TOWN OF WATERBURY EXHIBIT **A1**

ZONING PERMIT APPLICATION

Brief description of project: Revisions to the previously approved 9-lot PUD approved under 082-20,
including removing Lot 3, revising access to Lot 7, adding a dwelling unit
on Lot 2, and miscellaneous property line/acreage changes.

<p>REVISION 12/12/2020 REVISED LAYOUT</p>	
<p>OVERVIEW HONEYSUCKLE HILL NINE LOT SUBDIVISION JOHN MUTCHLER & PERRIN WILLIAMS</p>	
<p>SWEET & RIPLEY ROADS WATERBURY, VT</p>	
<p>SCALE : 1" = 200' DESIGNED BY: GNM PROJECT #25130D DRAWN BY: WDB CHECKED BY: GNM</p>	<p>MCCAIN CONSULTING, INC. 93 SOUTH MAIN STREET WATERBURY, VERMONT 05676</p>
<p>DATE: JULY 22, 2020</p>	<p>SHEET C-1</p>

SITE PLAN - LOT 2
HONEYSUCKLE HILL
NINE LOT SUBDIVISION
JOHN MUTCHLER & PERRIN WILLIAMS
SWEET & RIPLEY ROADS WATERBURY, VT

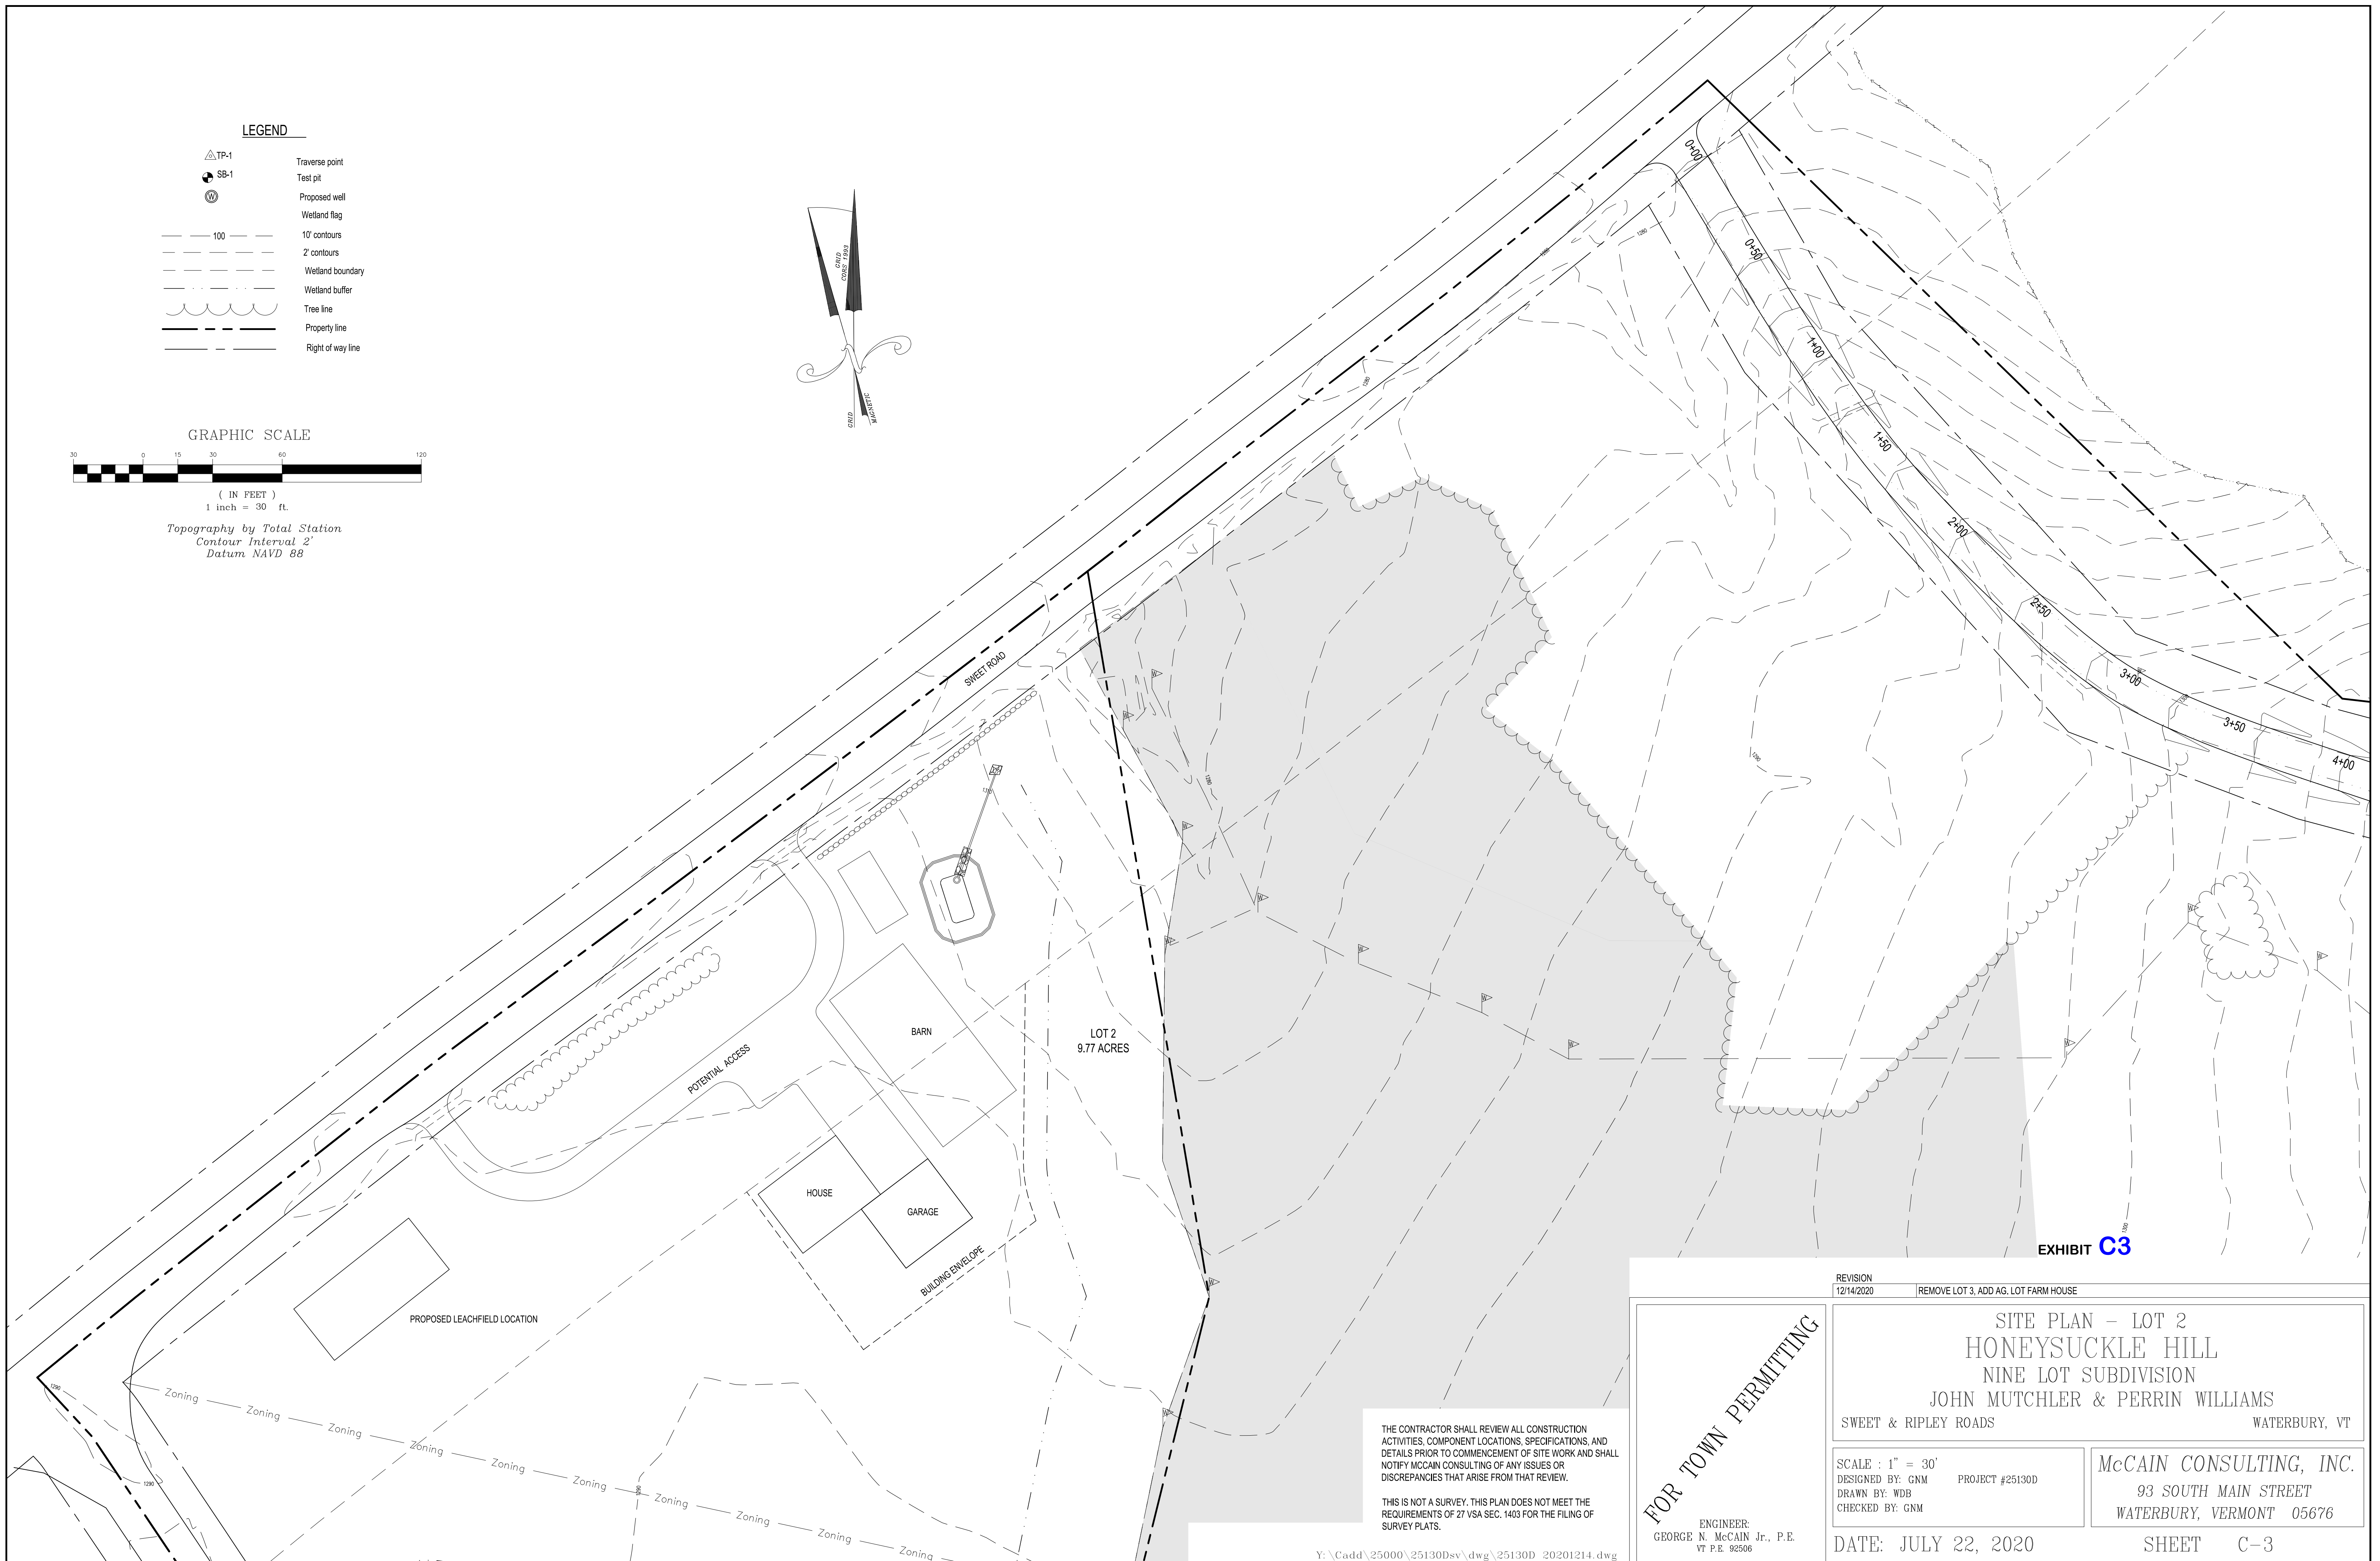
Several areas for that house site were considered, and due to various constraining factors the only viable location was on Lot 2 near the proposed barn. The attached plans depict this location for a farmhouse, and Lot 3 has been eliminated.

REVISION
12/14/2020 REMOVE LOT 3, ADD AG. LOT FARM HOUSE

ACCESS PLAN
HONEYSUCKLE HILL
NINE LOT SUBDIVISION
JOHN MUTCHLER & PERRIN WILLIAMS
SWEET & RIPLEY ROADS WATERBURY, VT

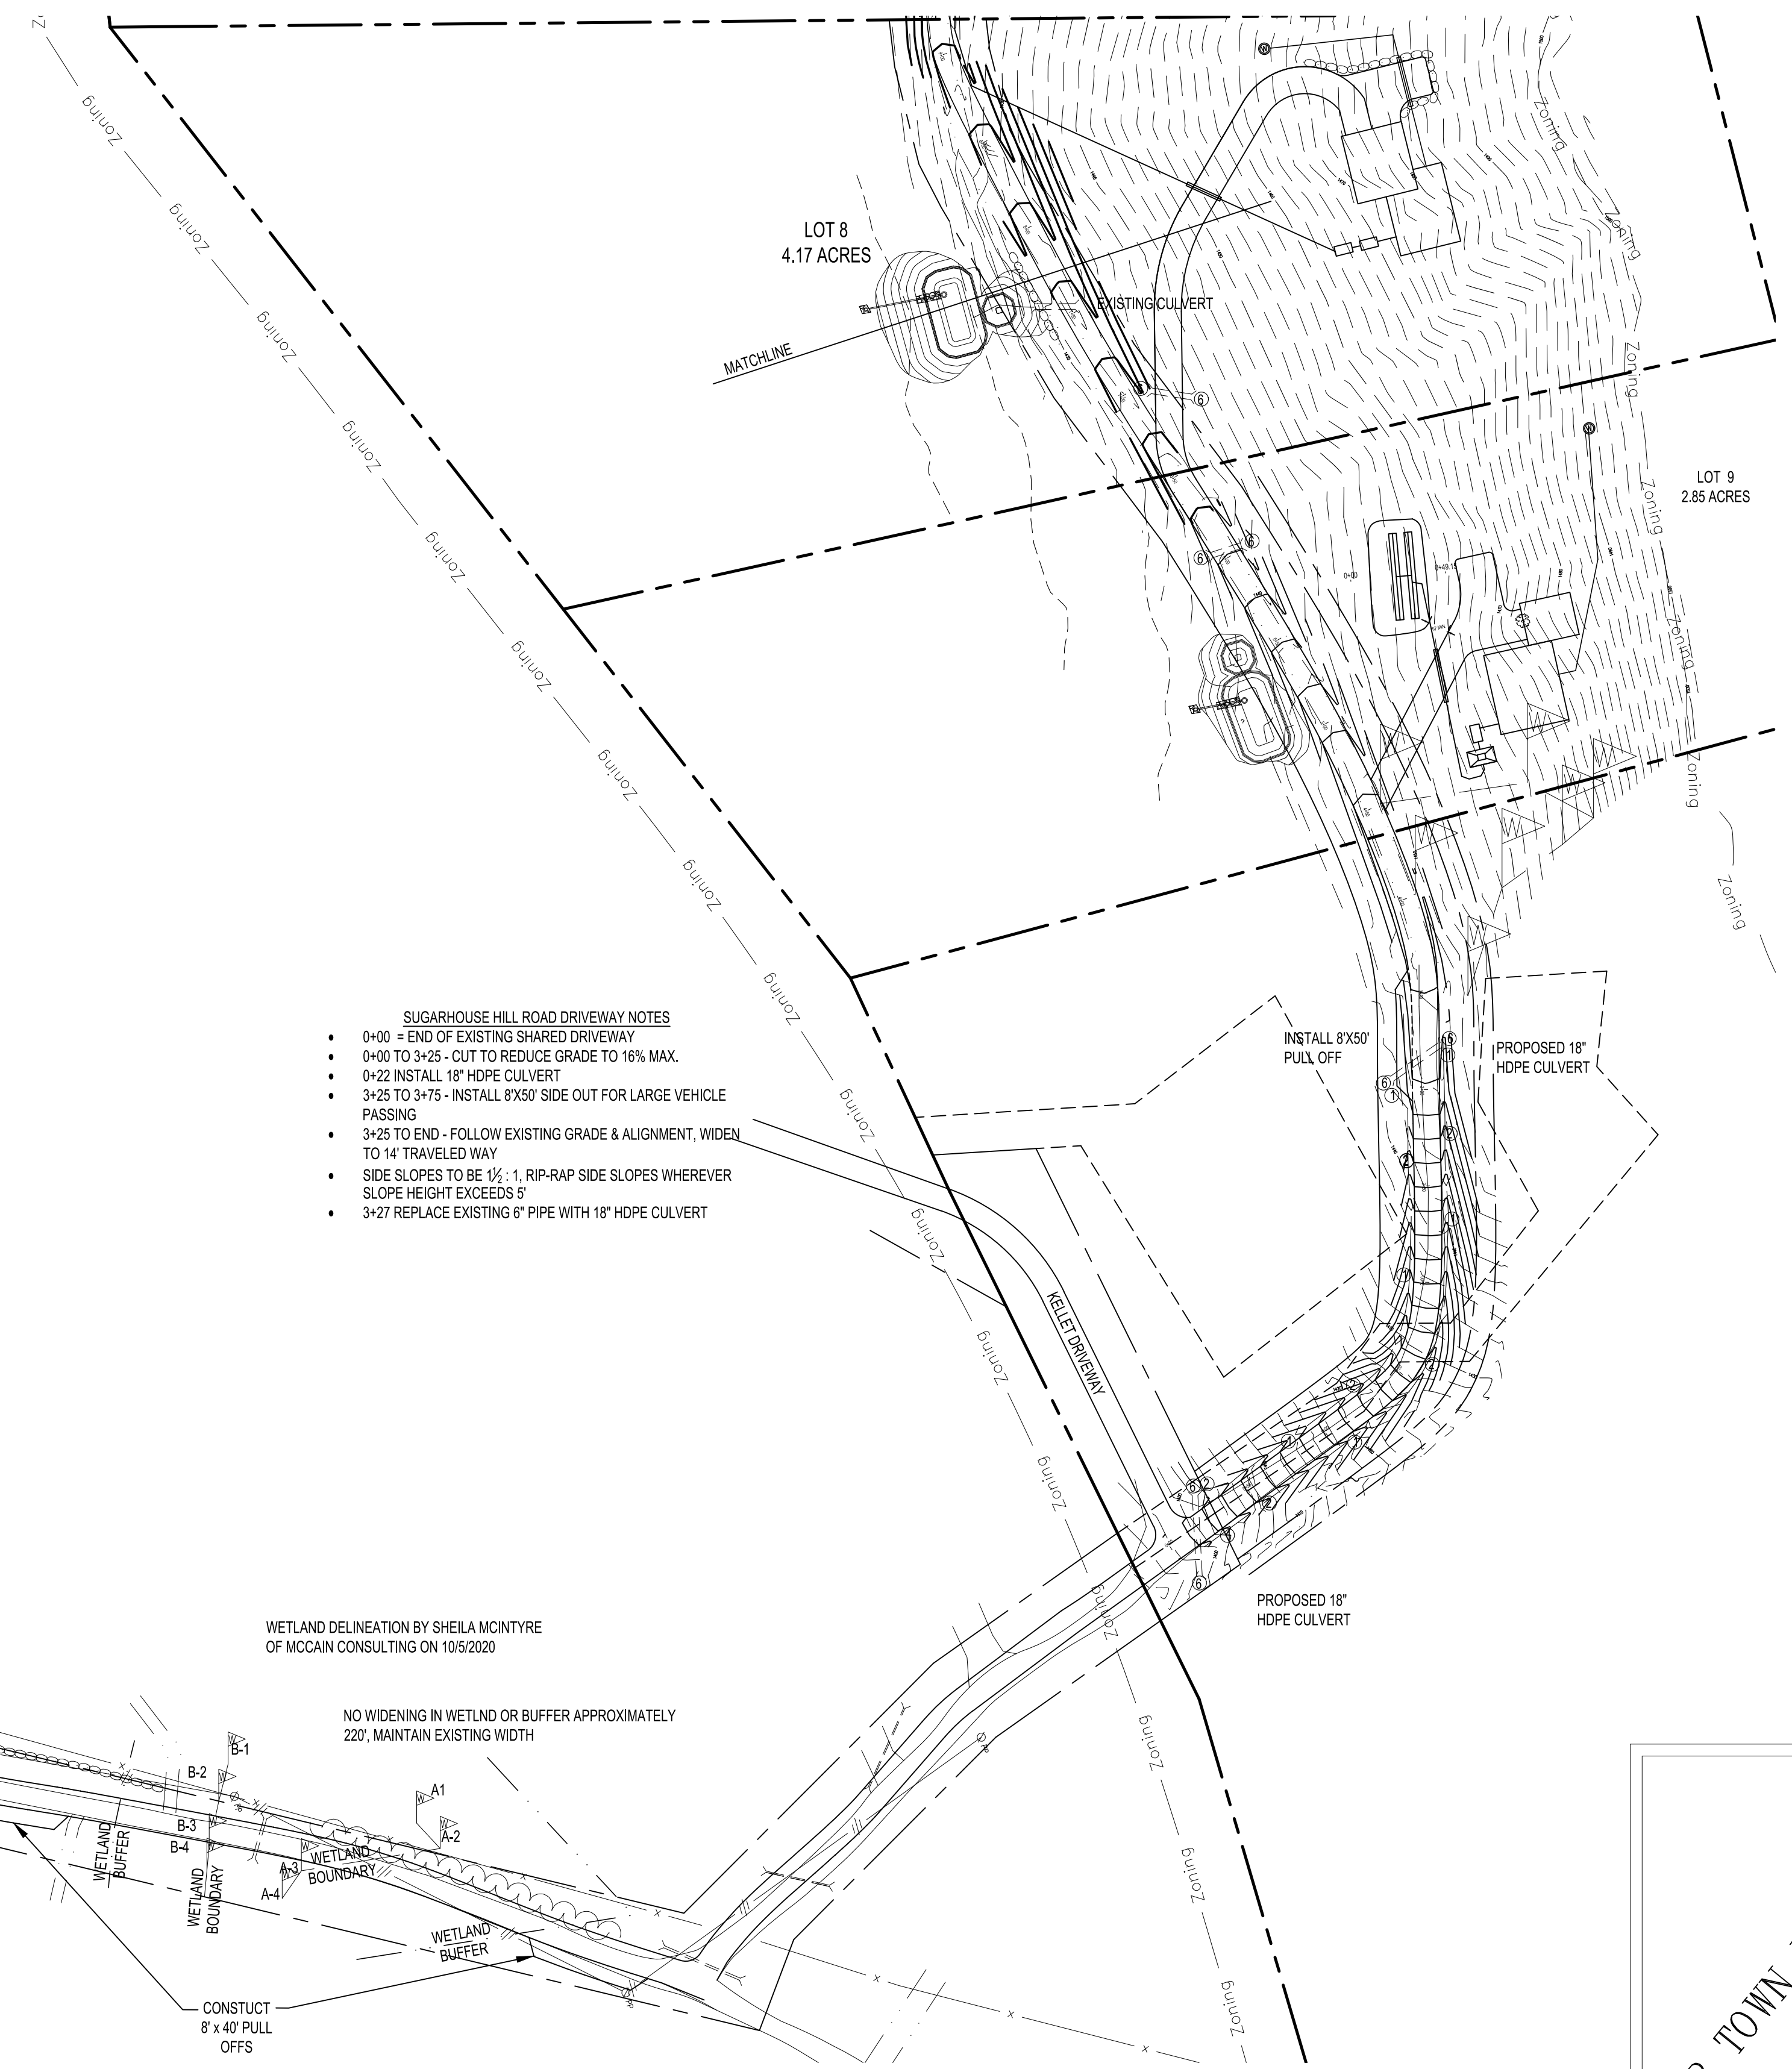
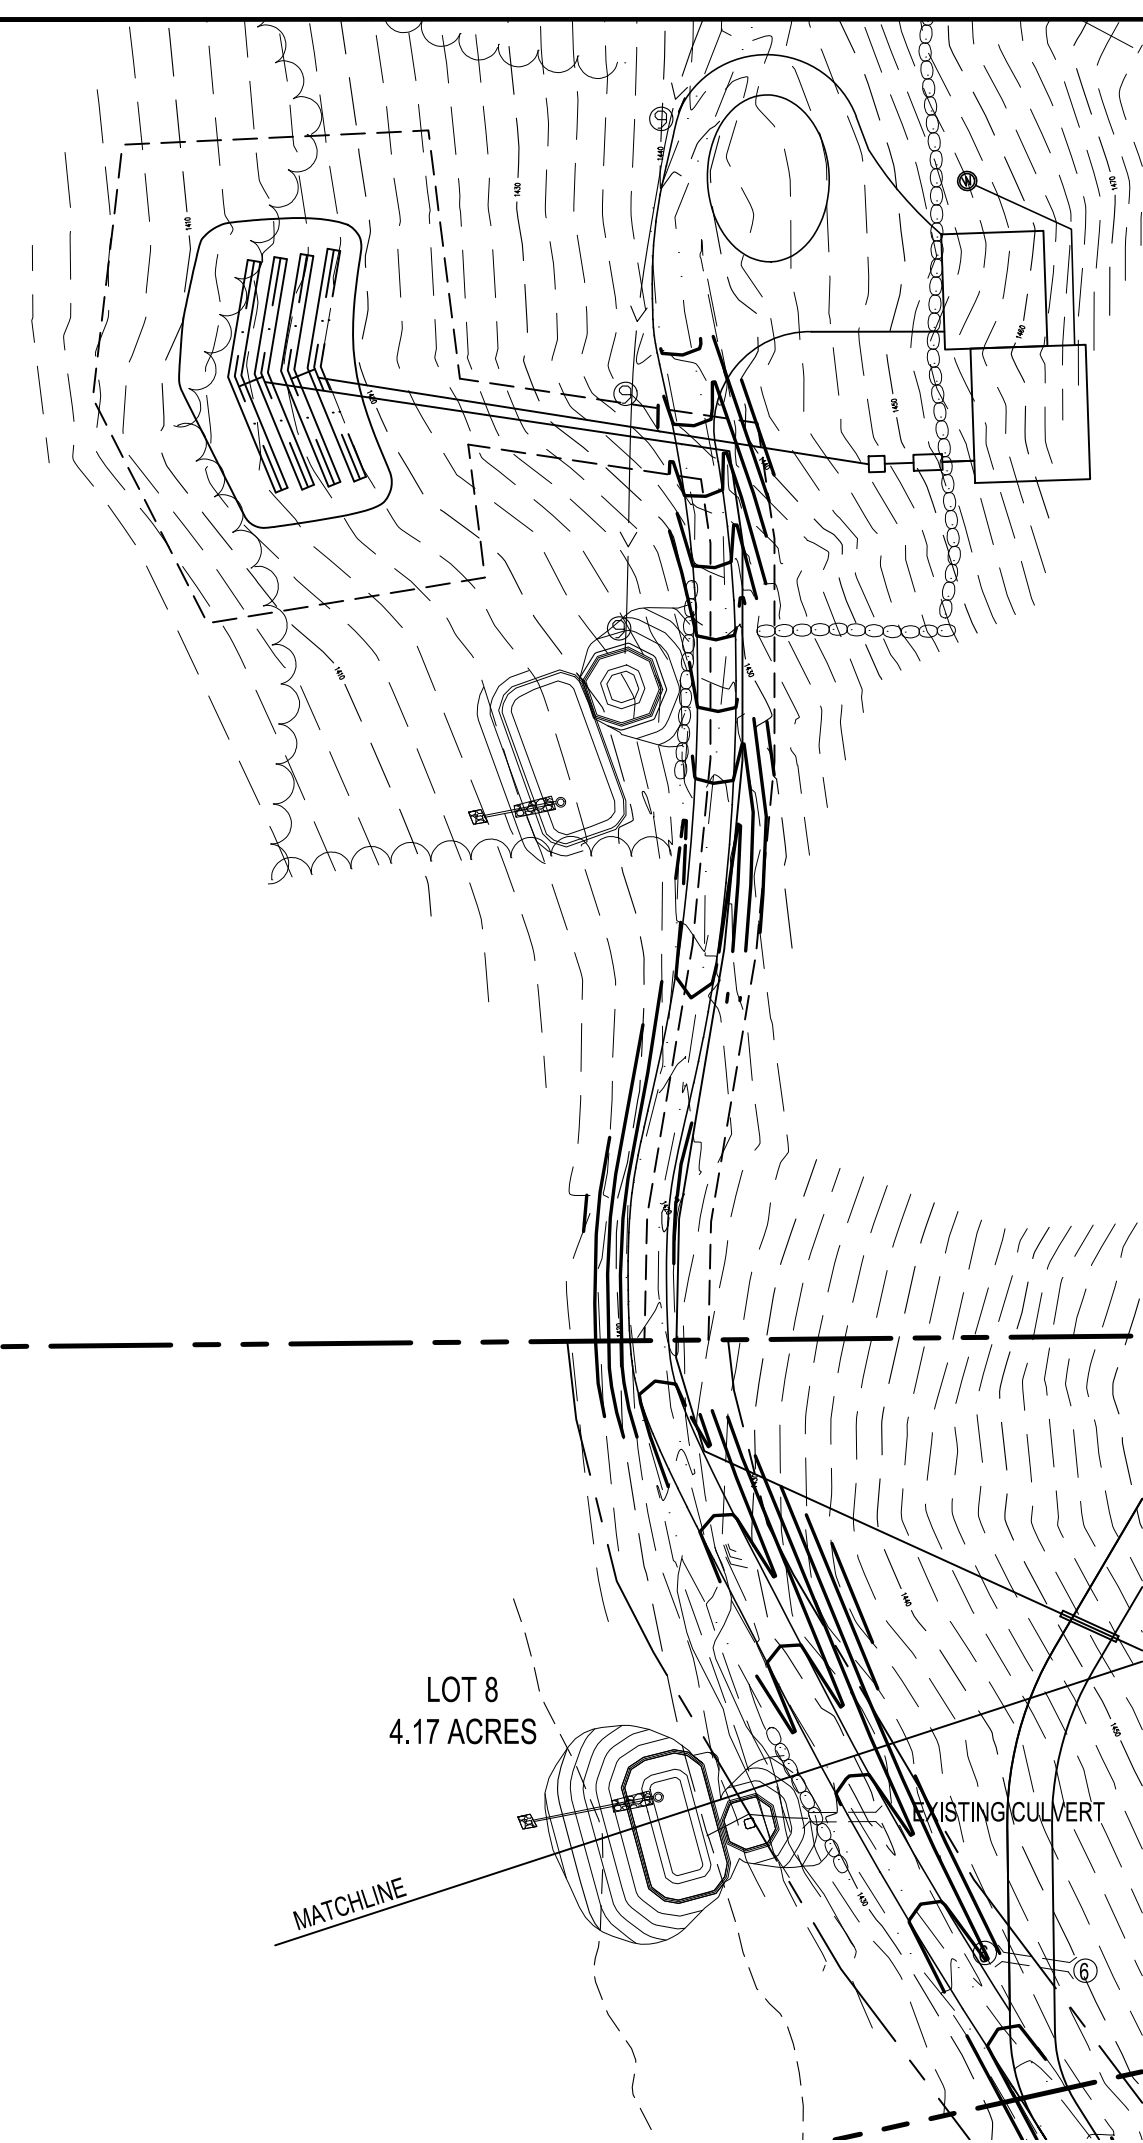
REVISION	REVISION
12/14/2020	REVISED DRIVEWAY LAYOUT FOR LOT 7
